NOTICE TO ALL CONTRACTORS:

Proposal #40: 1196-04-77
New Auburn – Rice Lake
B-03-14,16,18,20,26,30,37,218
USH 53
Barron County

This is Addendum No. 01, which provides for the following:

ADDENDUM NO. 01

Addendum No. 01
ID 1196-04-77
Revised Sheet 77
March 3, 2025

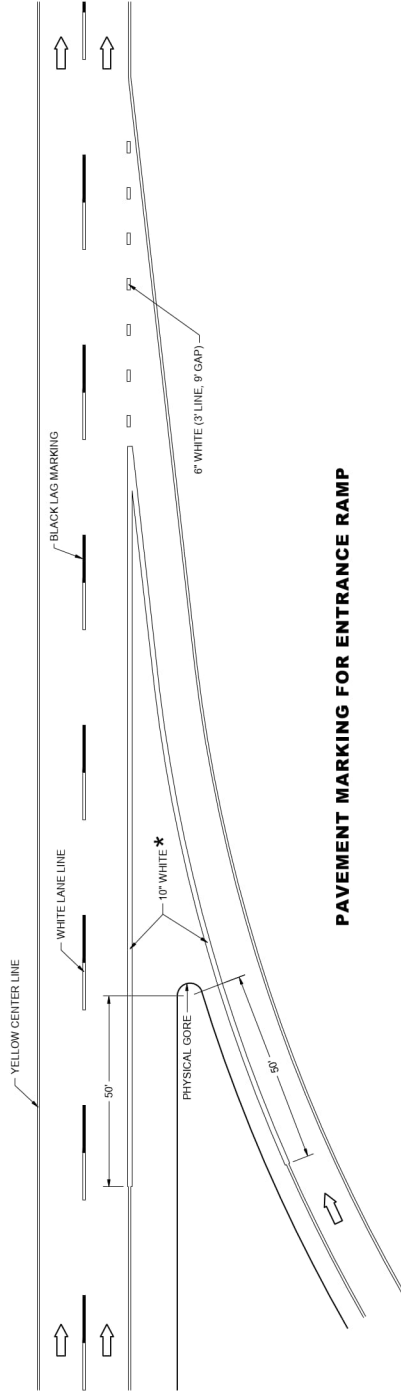
Revised Plan Sheets	
Plan Sheet	Plan Sheet Title (brief description of changes to sheet)
77	Miscellaneous Quantities: Temporary Marking Line miscellaneous quantity table update (643.3170 Temporary Marking Line Epoxy 6-Inch quantity between Station 843+23 SB and Station 856+36 SB updated to account for 3-foot segment/9-foot gap within lane drop).
296	Structure Plan Sheet: B-3-26 (eliminated north abutment bearing removals).
297	Structure Plan Sheet: B-3-26 (eliminated north abutment bearing removals).

792+50 SB - 809+04 SB	1,420			---	1,430	205	200	---	
843+23 SB - 856+36 SB	300			---	---	235	225	---	
865+68 SB - 882+86 SB	1,430			---	---	---	---	250	
889+31 SB - 896+81 SB	200			---	1,430	290	290	---	
STAGE 2 SUBTOTALS		11,960	---	---	---	---	400		
CTH I		---	---	---	1,320	---	---		
STAGE 2 SUBTOTALS		11,960	---	11,615	1,985	3,270	1,050		
TOTALS		26,260		26,435		1,255

Addendum No. 01
ID 1196-04-77
Added Sheet 186A
March 3, 2025

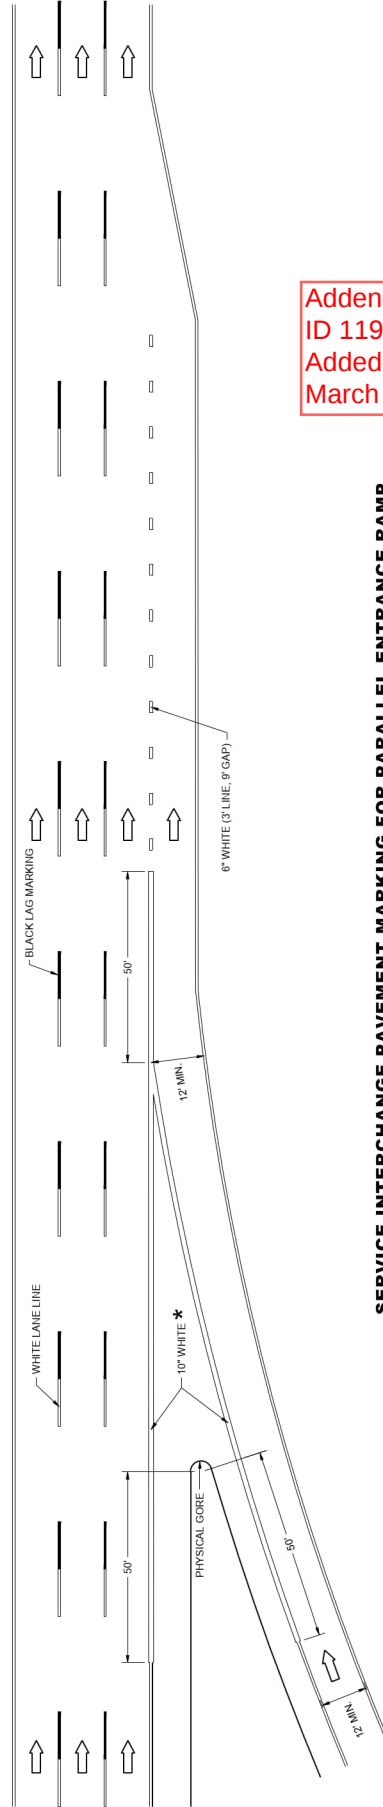
Added Plan Sheets	
Plan Sheet	Plan Sheet Title (brief description of why sheet was added)
186A	Added Standard Detail Drawing "Pavement Marking, Entrance Ramp and Parallel Entrance Ramp."

Addendum No. 01
ID 1196-04-77
Revised Sheet 296
March 3, 2025

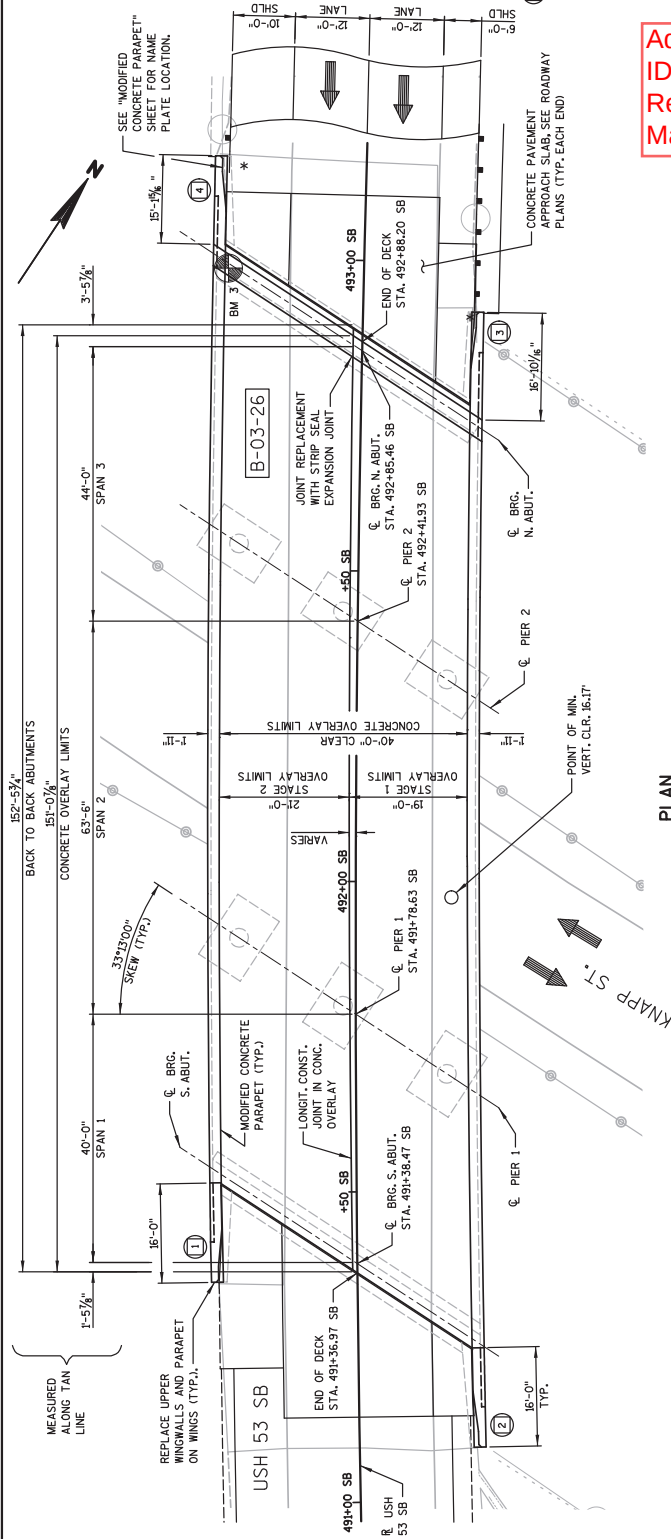
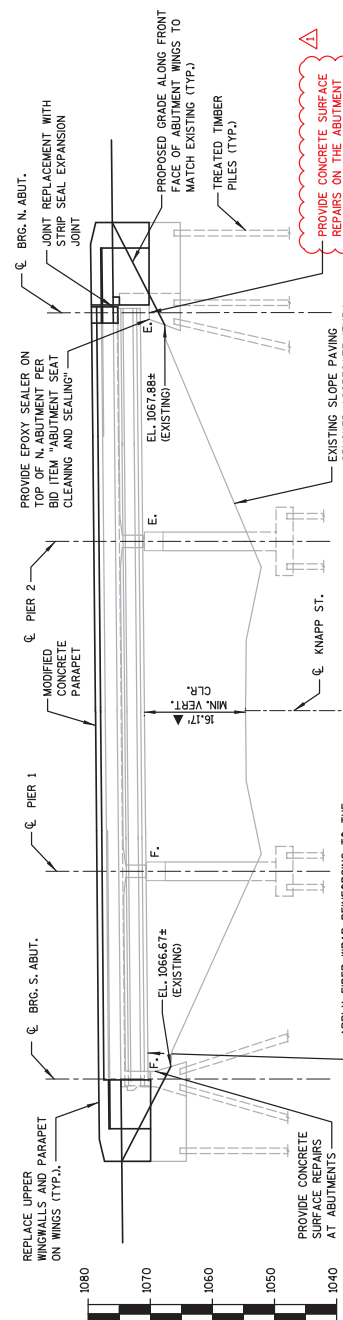
NO.	DATE	REVISION	BY
1	1/26/24	ELIMINATE BEARING REMOVAL	BMO

Addendum No. 01
ID 1196-04-77
Revised Sheet 297
March 3, 2025

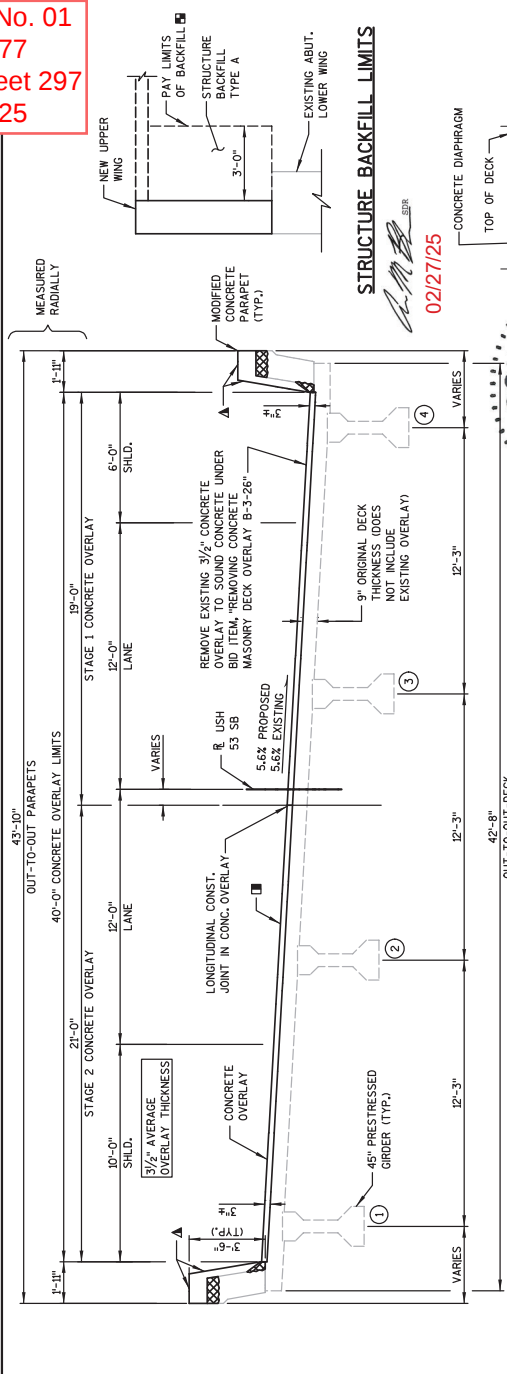
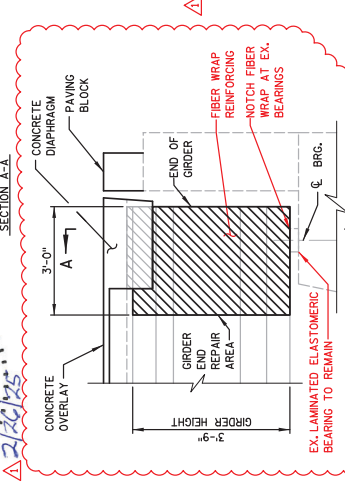
ELIMINATE BEARING REMOVAL
BY
